NCC Public Comment Draft response sheet

Organisation(s): Joint submission by Australian Institute of Architects and the Association of Consulting Architects Australia

Clause/Figure/Table: F1D4(1)

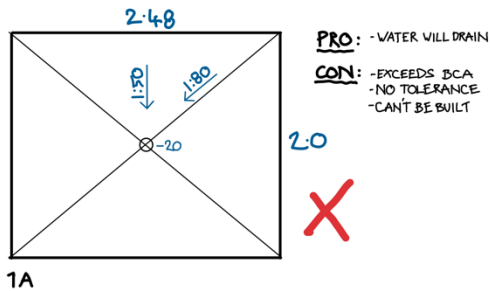
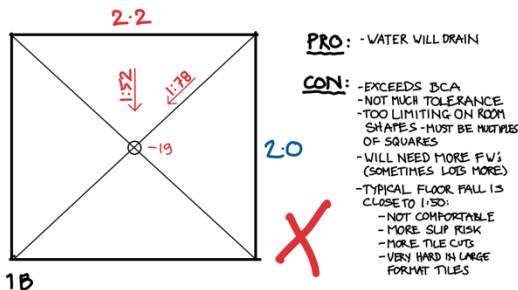
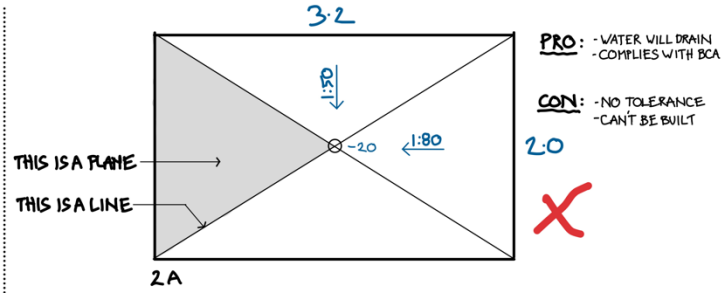
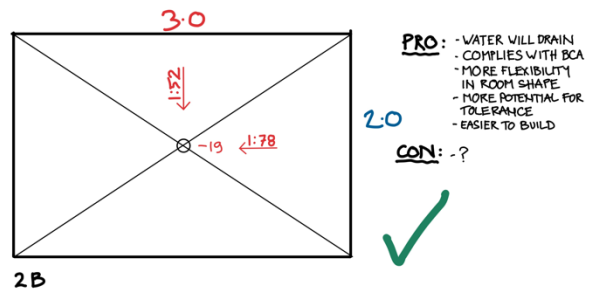
Comment/reason for change:

This inclusion would bring consistency with the similar clause, F2D4(2), regarding internal wet areas introduced in BCA 2022. The additional note describing the meaning of 'plane' is critical as this is causing significant confusion in the industry and is being misinterpreted by many people. For clarity, when recommending that the 1:80 falls be nominated for external balconies etc. the Technical Reference Group intended this as being on the plane, not measured on the diagonal, and reflects the TRG's intent when including the word 'plane' in clause F2D4(2) for internal wet areas. Whilst providing clarity and preventing unnecessary confusion and costly rework related to F1D4 being considered in this draft, it would also clarify the intent of the existing clause for internal wet areas without having to make any actual changes to the existing clause F2D4(2). As background, with regard to Clause F2D4(2) Floor Wastes (relevant to internal wet areas) the requirement for minimum 1:80 falls in the plane of the floor combined with the recently added requirement for maximum falls of 1:50, makes bathroom falls almost impossible to achieve if the interpretation of 'plane' includes the diagonal intersection. This interpretation is being adopted by certifiers believing it to be the most onerous possible interpretation. Unfortunately, by taking this convoluted view, they are backing the industry into a situation where compliance is almost unachievable. To achieve a minimum 1:80 fall at the diagonal and a 1:50 maximum fall on the plane (perpendicular to the wall) the area being drained has to be almost perfectly square and has almost no ability to design in tolerance to allow for the realities of placing concrete. With this interpretation, for a completely square space, if the concrete is poured with the waste level even 2mm up or down from its designed level, the floor would be noncompliant. This level of tolerance is not achievable in concrete. It is unrealistic in the extreme to expect that all bathrooms will be made up of purely square spaces and as such, many bathrooms currently being designed would require 4 or more floor wastes for a small bathroom. It should also be noted that even in square areas with single outlets, the predominant fall of all the floor planes will be almost exactly 1:50 which means that almost all parts of a bathroom floor will be at the maximum permissible fall. This is undesirable as it becomes uncomfortable to walk on, particularly for people who are elderly, infirm or disabled. When also adding in the increased slip risk of unnecessarily steep falls in floors with water on them, this erroneous interpretation is therefore increasing confusion, complexity and cost while arguably providing a poorer level of amenity for building occupants. As noted above, our suggested changes to clause F1D4(1) and the explanatory notes will both prevent this unintended consequence from being repeated in external balcony areas as well as clarifying the intent of clause F2D4 without actually having to change F2D4.

F1D4

Provision Of Drainage and Grading to External Areas

(1) A concrete roof, balcony or similar part of a building must have

(a) the structural substrate graded with a minimum fall of 1:80 in the plane of the substrate to the floor drain, rainwater outlet or other drainage outlet;

Notes

For the purposes of this part, a tile bed, screed, topping, or similar component is not considered a structural substrate

For the purposes of section F, the plane of the floor or substrate is taken to mean the predominant fall of the surface in question, typically perpendicular to bounding walls, and is not referring to the diagonal intersection between planes.

except within planter boxes where it can be used to achieve the minimum fall of 1:80.

Clause/Figure/Table: F1D4

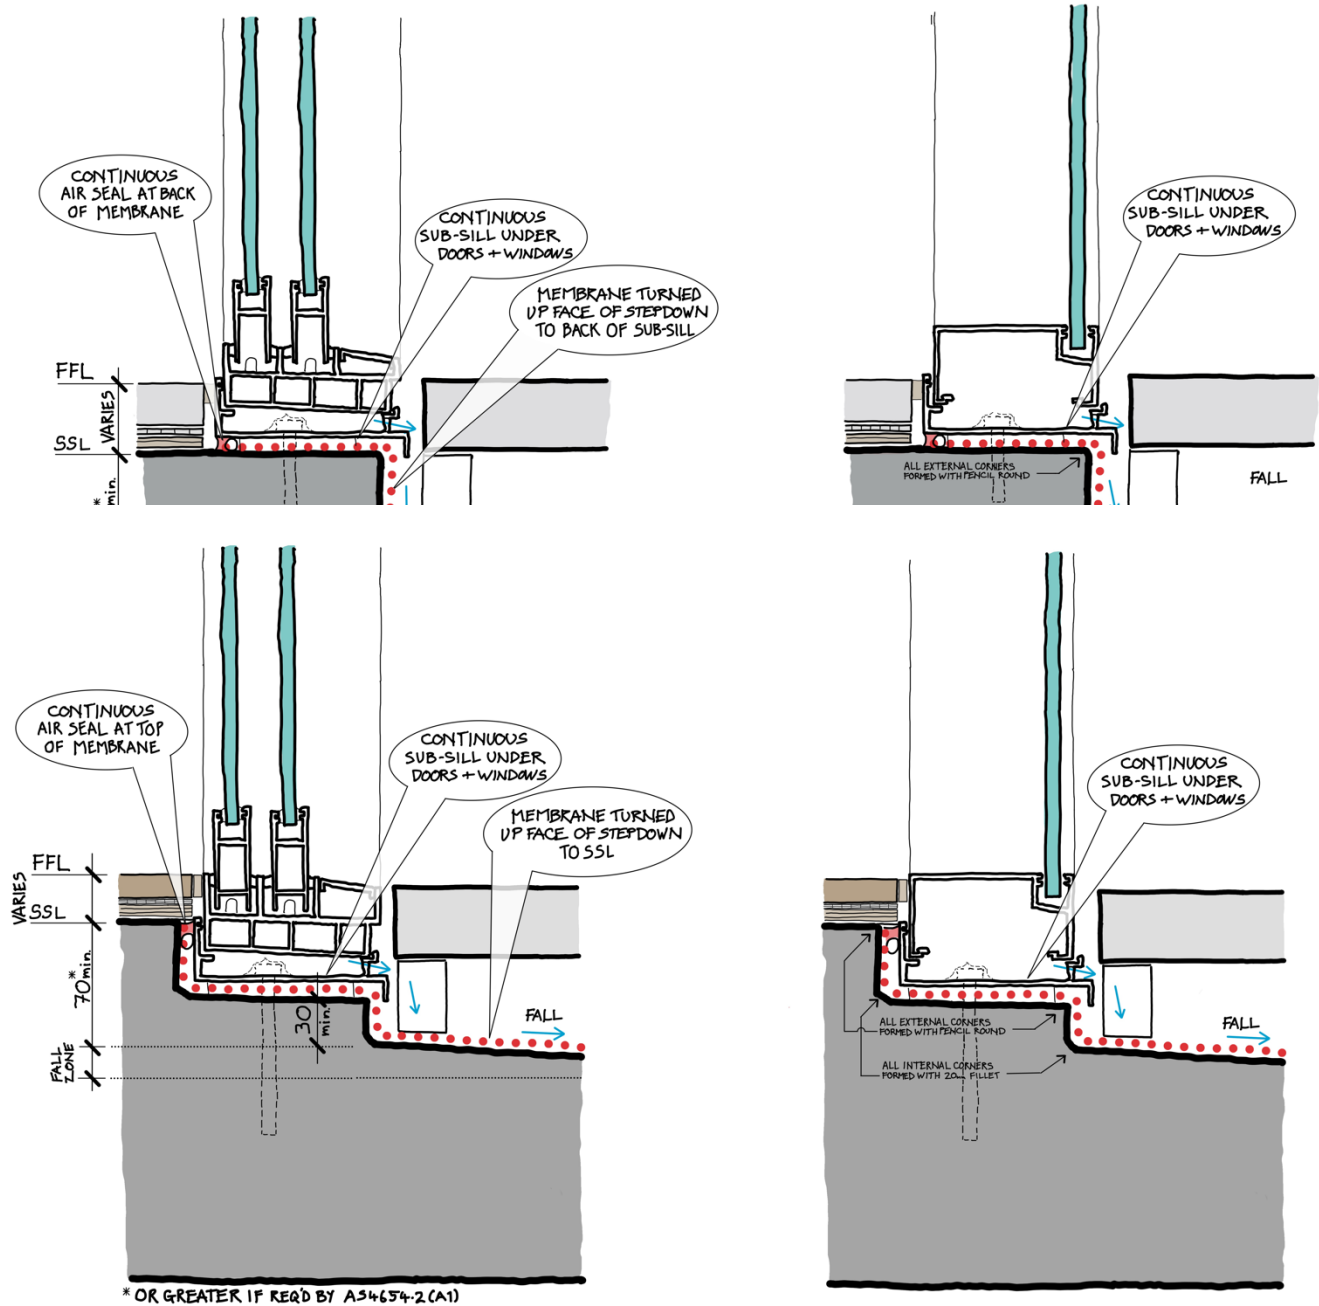
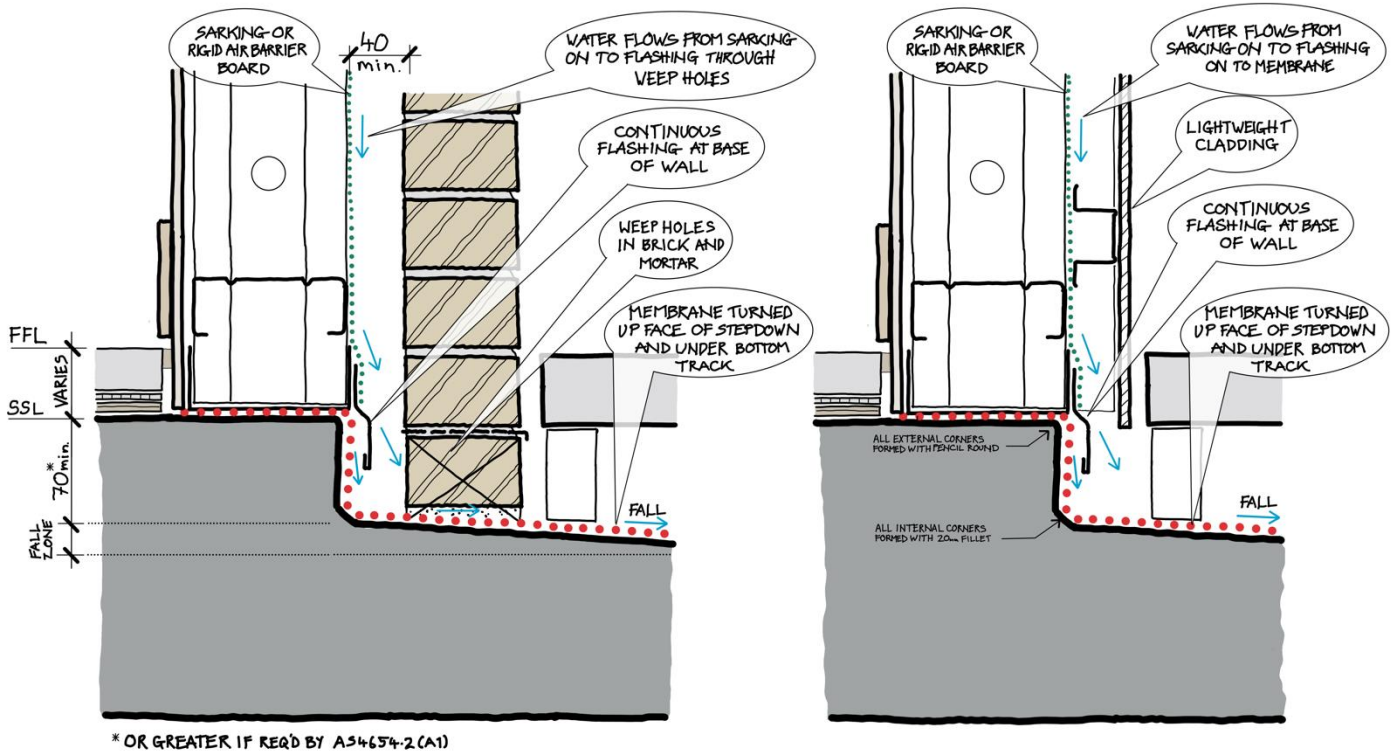
Comment/reason for change:

For Clause (a):

It is important to clarify that the 70mm stepdown is in the concrete / structure and is not from the internal floor finish level. If it was left without this clarification, there would be confusion as to which level the 70mm is measured. If certifiers interpret this as being allowable from the internal finished floor level, part or all of the stepdown would be formed by an applied angle on top of the concrete. This outcome would pose a

greater risk of water defects as the angle would be relying on sealant and membranes to maintain its capacity to 'collect' the water and prevent it from leaking into the inside. This would be similar to the cold joint at a concrete slab poured after the main slab has cured (which is a detail the proposed updates in this draft are specifically attempting to prevent.) See sketches below of how the stepdown should look in various examples

For Clause (b):

Clause (b) is clumsily worded to the point that clause (c) is required to clarify it. By changing the wording of clause (a) as we have suggested, we believe it would provide enough clarity to allow for the removal of clause (c).

(2) A concrete roof, balcony, podium, or similar part must have a minimum

(a) 70 mm step down from the internal ~~floor~~ structural slab level (SSL) to the external structural substrate; and

(b) 70 mm high integral hob around its outside edge perimeter; and

~~(c) F1D4(2)(b) does not apply where the external structural substrate abuts an external wall or door.~~
